**City of Portland, Maine – Building or Use Permit Application**, 389 Congress Street, 04101, Tel: (207) 874-8703, FAX: 874-8716

Location of Construction: 92 Penn Ave (Lot #3)		Owner: A & G Associates		Phone: 772-2127		Permit No: 981122	
Owner Address:		Lessee/Buyer's Name:		Phone:		Business Name:	
Contractor Name: A & G Assoc.		Address: 426 Forest Ave Ptd, ME 04101		Phone: 772-2127		Permit Issued: OCT 2 1998	
Past Use: Vacant Land		Proposed Use: 1-fam		COST OF WORK: \$ 120,000.00		PERMIT FEE: \$ 620.00	
				FIRE DEPT. <input type="checkbox"/> Approved <input type="checkbox"/> Denied		INSPECTION: Use Group: Type: B	
Proposed Project Description: Construct Single Family Dwelling				Signature:		Signature:	
				PEDESTRIAN ACTIVITIES DISTRICT (P.A.D.) Action: Approved <input type="checkbox"/> Approved with Conditions: <input type="checkbox"/> Denied: <input type="checkbox"/>		Zoning Approval: Special Zone or Reviews: <input type="checkbox"/> Shoreland <input type="checkbox"/> Wetland <input type="checkbox"/> Flood Zone <input type="checkbox"/> Subdivision <input type="checkbox"/> Site Plan maj <input type="checkbox"/> minor <input type="checkbox"/> mm <input type="checkbox"/>

**RE:**

SITE PLAN  
 PENN AVENUE  
 PORTLAND, MAINE

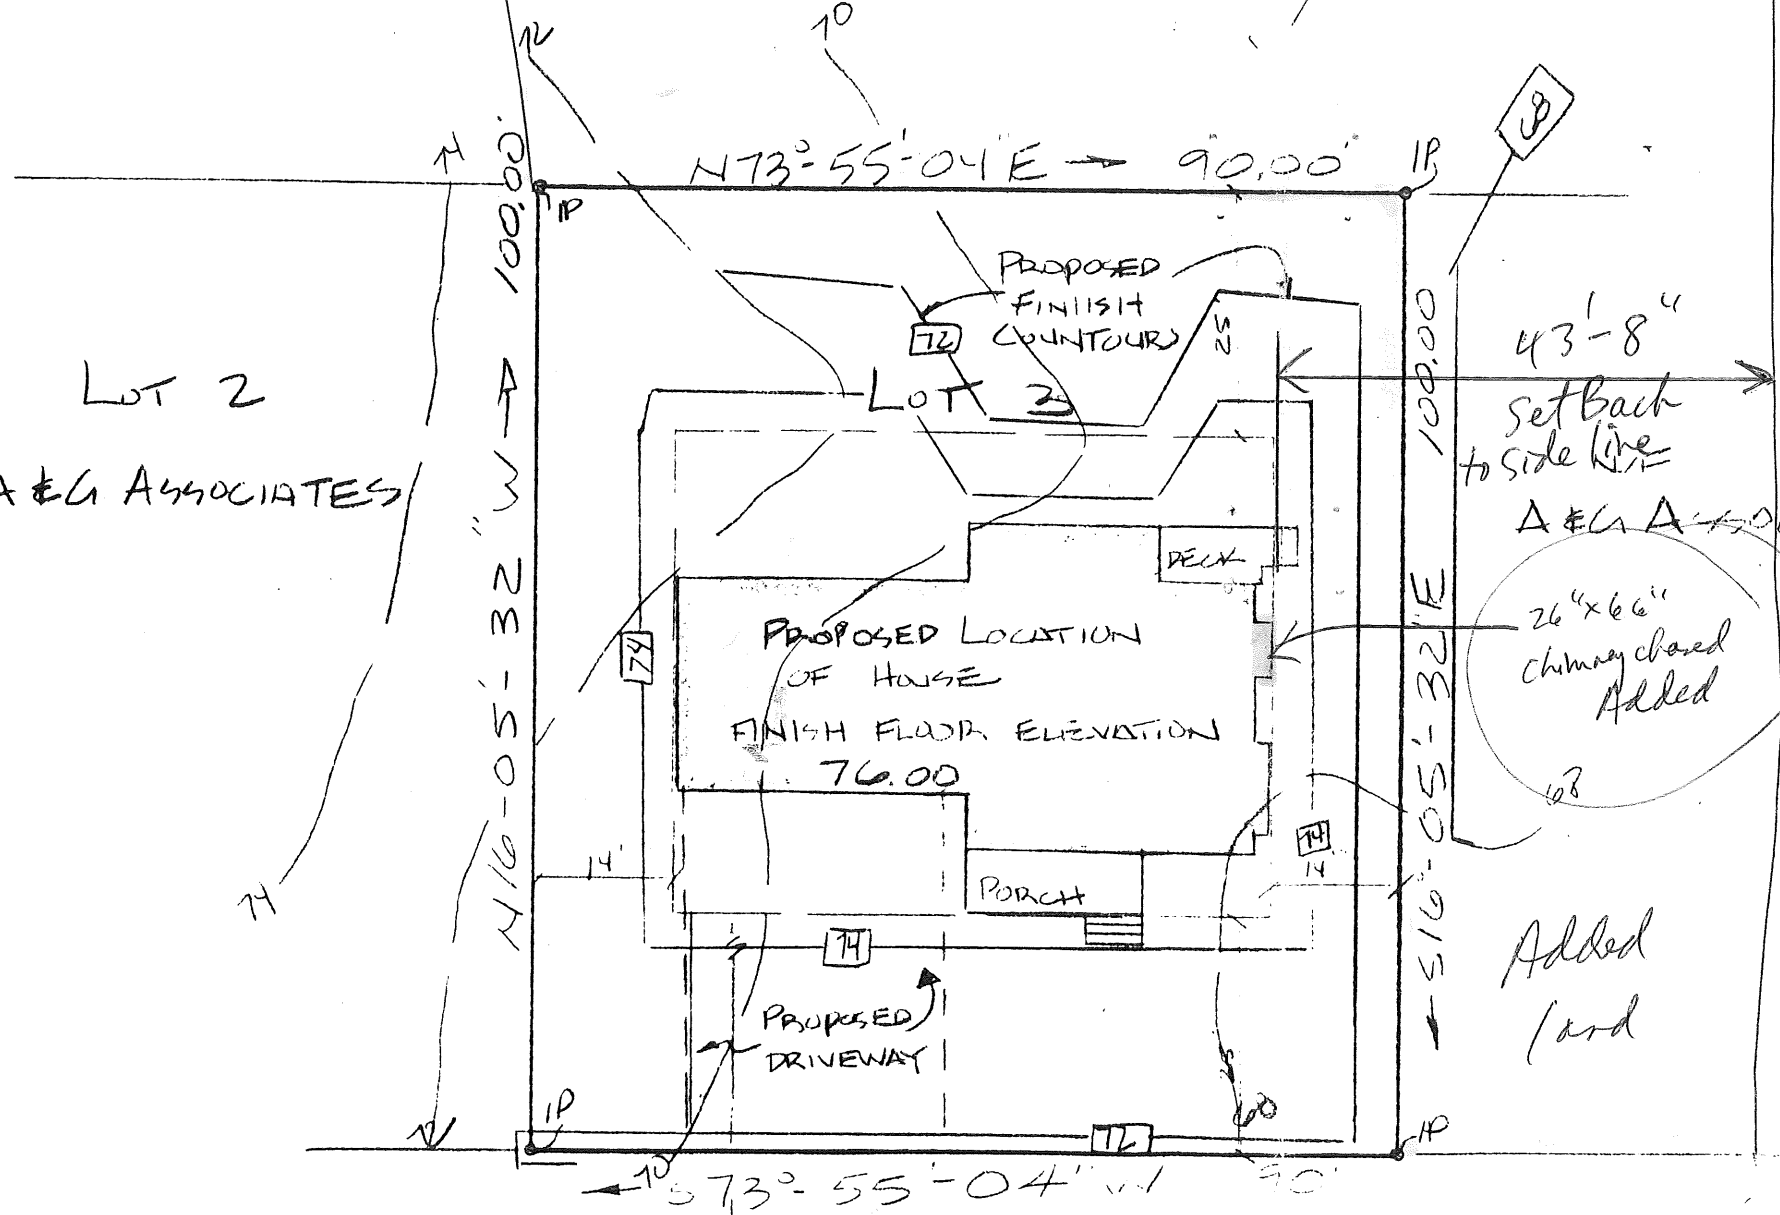
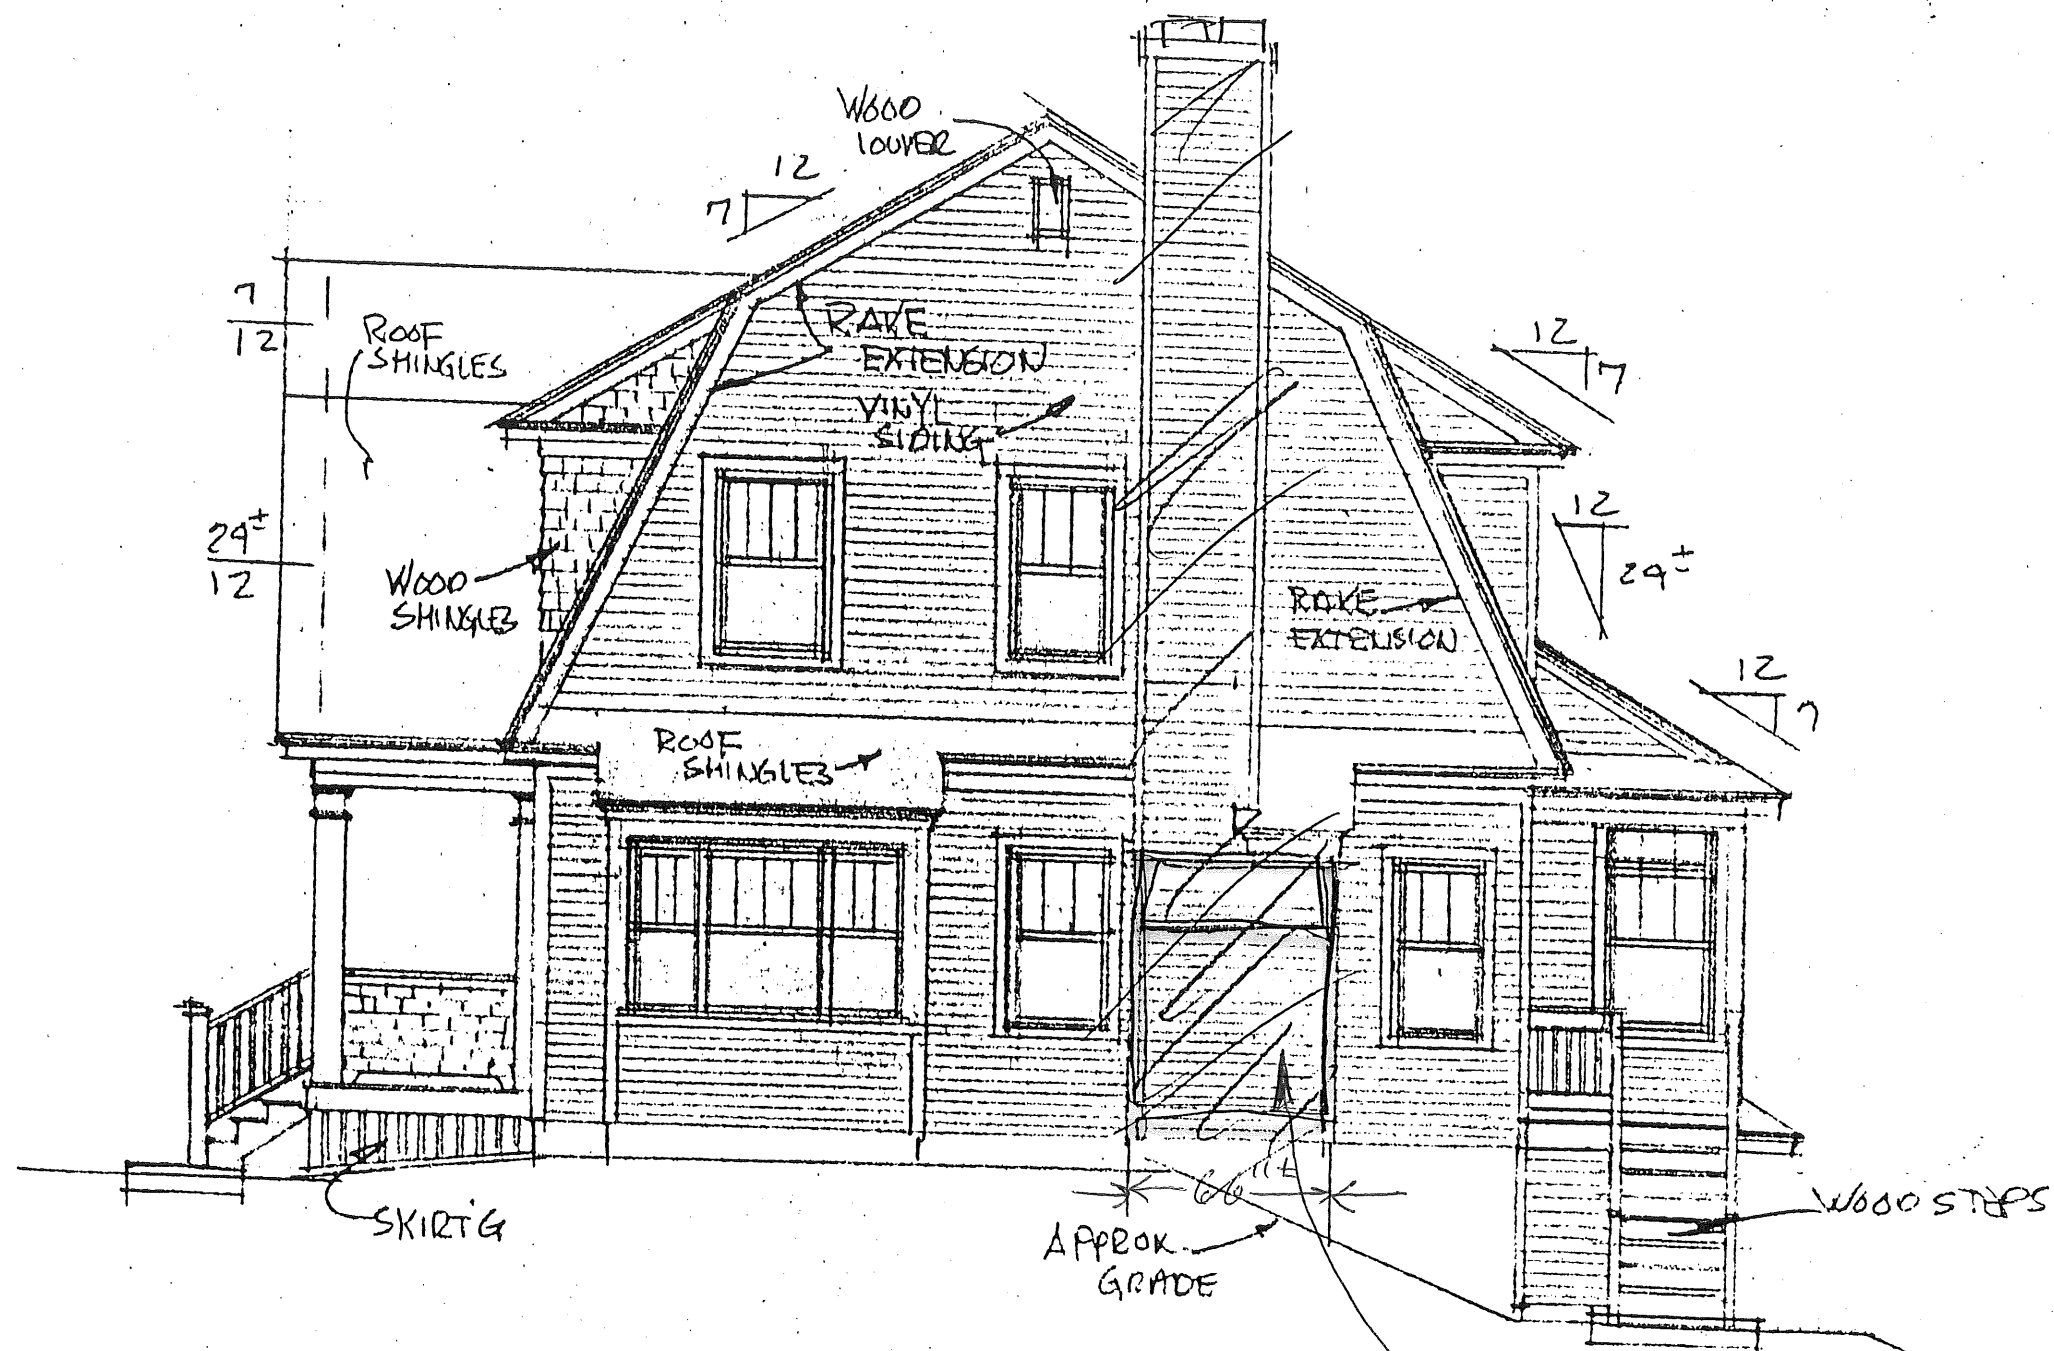
N/F A. & G. ASSOCIATES  
*Added land*

*Setback OK 2/22/99*

*Added land*
